2019/01/26

## MVMB/MVMC-LB/TB-22 Series Mechanical Valve Exterior of Switch Change Notification

### 3.1 LB type switch

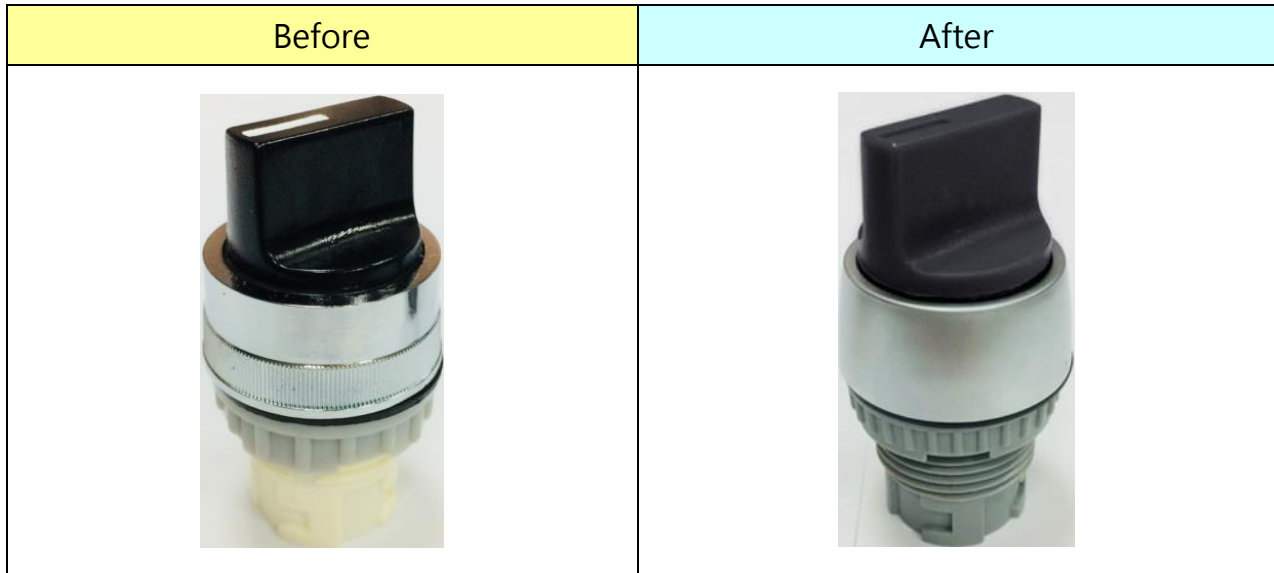
1. Product Series  
MVMB/MVMC-LB/TB-22 Series Mechanical Valve.
2. Design Change Reason  
For product aesthetics, change the exterior of switch.
3. Design Change
